Subject: AP1000 Response to Request for Additional Information (SRP 11)

RAI-SRP11.5-CHPB-05

AP1000 TECHNICAL REPORT REVIEW

RAI Response Number: RAI-SRP11.5-CHPB-05

Figure 5.2-1

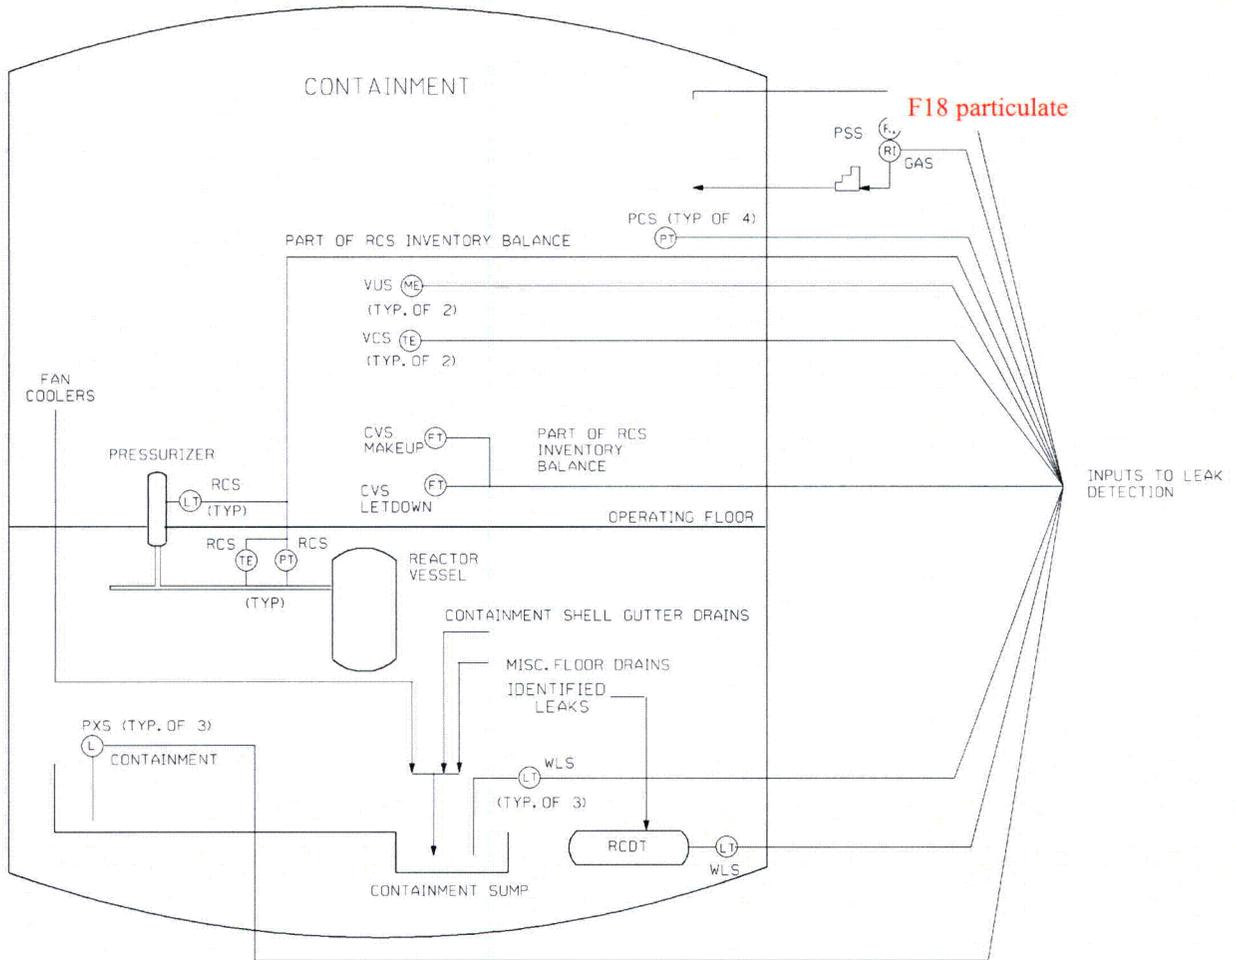
Staff review of Change Number 45 to DCD Tier 2 (Rev 18) Appendix 1A, sections 3.1.4, 3.6.3.3, 5.2.5.3.3, and 11.5.2.3.1, and LCO 3.4.9 sections B.3.4.7 and 3.4.9 indicate that the applicant provided insufficient information in regards to the new containment particulate radiation monitor (PSS-JE-RE027) sensitivity to satisfy the reactor coolant system (RCS) leakage rate technical basis. The technical basis for the RCS leakage detection instruments and RG 1.45 (Rev1) establish radiation monitor sensitivity requirements for leakage detection increase of 1 gpm within 1 hour using a realistic primary coolant concentration. Although Change Number 45 specifies the radiation monitor sensitivity for particulate radioactivity, the change does not provide an analysis to demonstrate that the specified monitor sensitivity is capable of satisfying the technical basis using realistic radioactive concentrations in the RCS.

Leakage from the reactor coolant pressure boundary will result in an increase in the radioactivity levels inside containment. The containment atmosphere is continuously monitored for airborne ~~gaseous~~ **particulate** radioactivity. Air flow through the monitor is provided by the suction created by a vacuum pump. ~~Gaseous N_{13}/F_{18} concentration monitors indicate~~ An F_{18} ~~particulate concentration monitor indicates~~ radiation concentrations in the containment atmosphere.

~~N_{13} and F_{18} are neutron activation products which are~~ **particulate** is a neutron activated product, which is proportional to power levels. An increase in activity inside containment would therefore indicate a leakage from the reactor coolant pressure boundary. Based on the concentration of ~~N_{13}/F_{18} in~~ **particulate form** and the power level, reactor coolant pressure boundary leakage can be estimated.

Figure 11.5-3
Containment Atmosphere Radiation Monitor

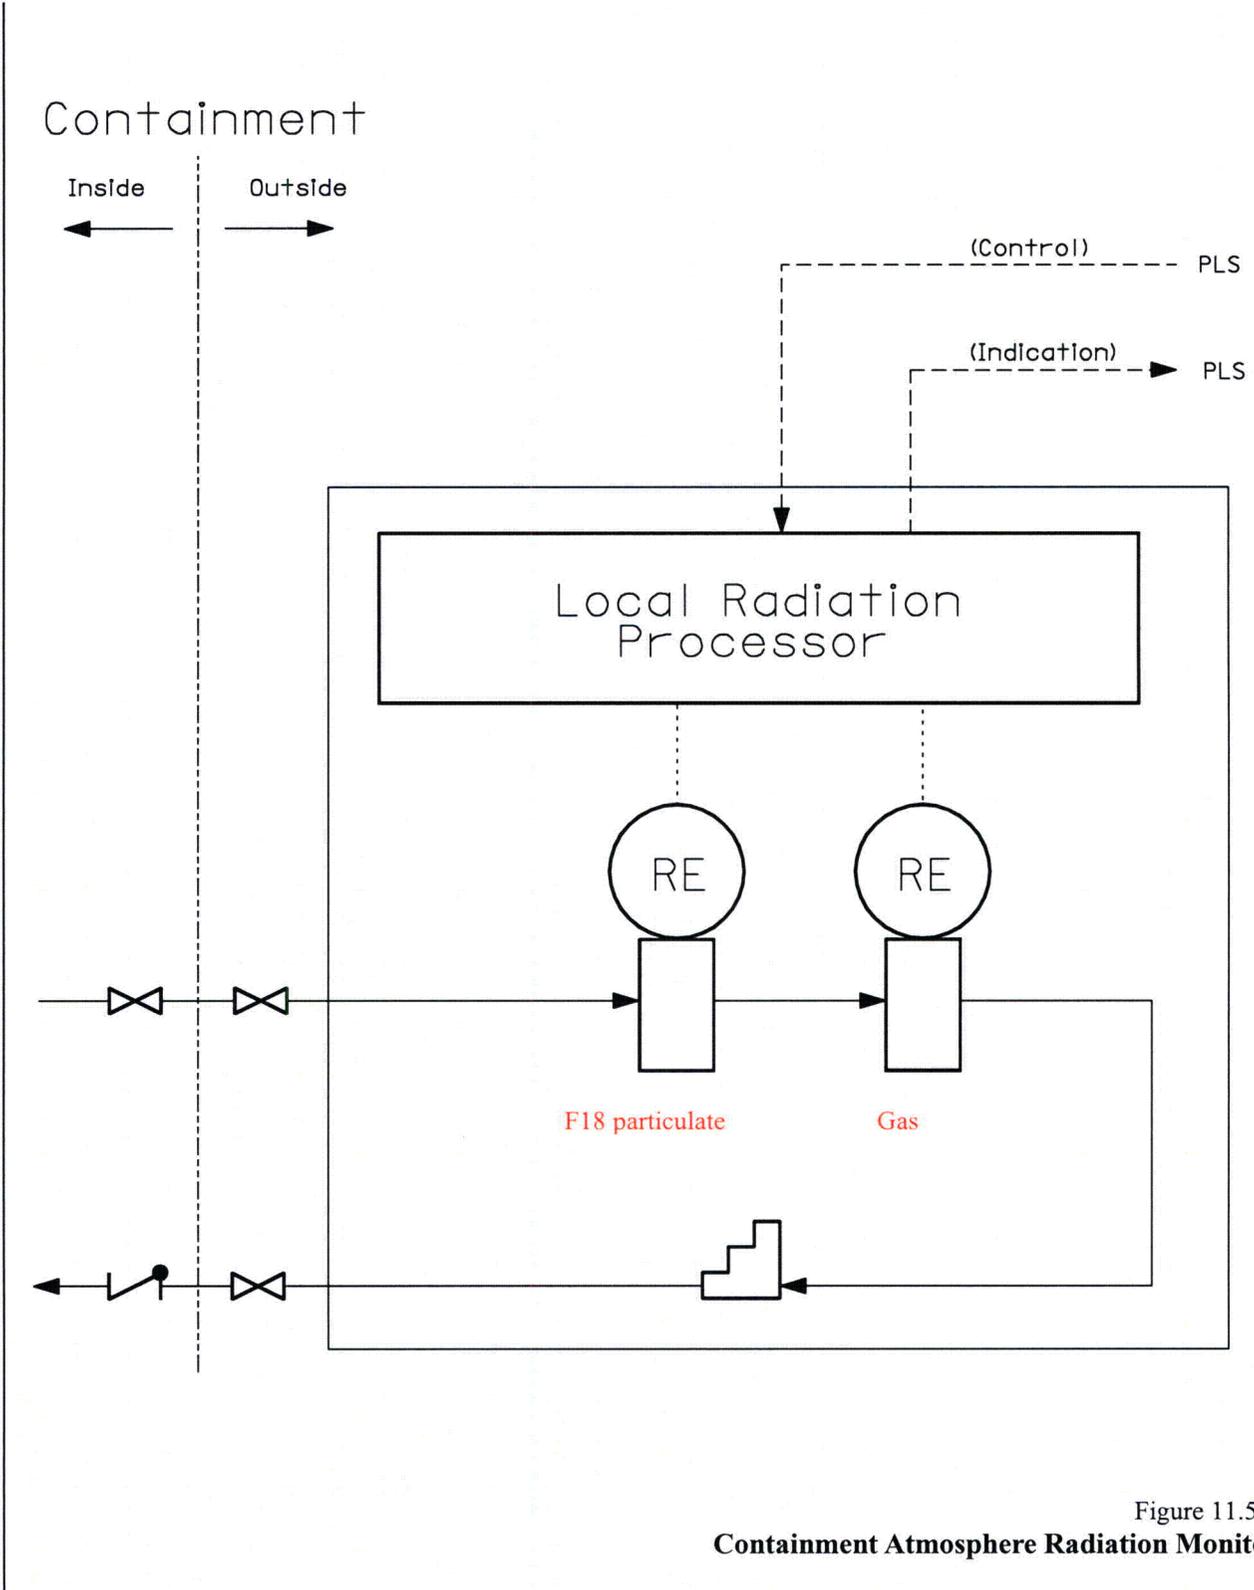
Please provide an analysis to demonstrate that the particulate radiation monitor sensitivity is capable of satisfying the technical basis for the RCS leakage using a realistic radioactive concentration in the RCS. Include in this analysis all models, modeling assumptions and their basis, parameter values and their basis, and any references.

The containment atmosphere radiation monitor measures the radioactive gaseous (PSS-JE-RE026) and N^{13}/F^{18} particulate (PSS-JE-RE027) concentrations in the containment atmosphere. The containment atmosphere radiation monitor is a part of the reactor coolant pressure boundary leak detection system described in subsection 5.2.5. The presence of gaseous or N^{13}/F^{18} radioactivity in the containment atmosphere is an indication of reactor coolant pressure boundary leakage. Refer to subsection 5.2.5 for further details. Conformance with Regulatory Guide 1.45 is discussed in Appendix 1A.

The radiogas detector is a beta-sensitive scintillation detector. The N^{13}/F^{18} ~~detector is a gamma sensitive, thallium activated, sodium iodide scintillation detector with a window at the N^{13}/F^{18} 0.511 MeV decay energy~~ particulate detector is also a beta-sensitive scintillation detector. The ranges and principal isotopes are listed in Table 11.5-1.

The arrangement for the containment atmosphere radiation monitor is shown in Figure 11.5-3.
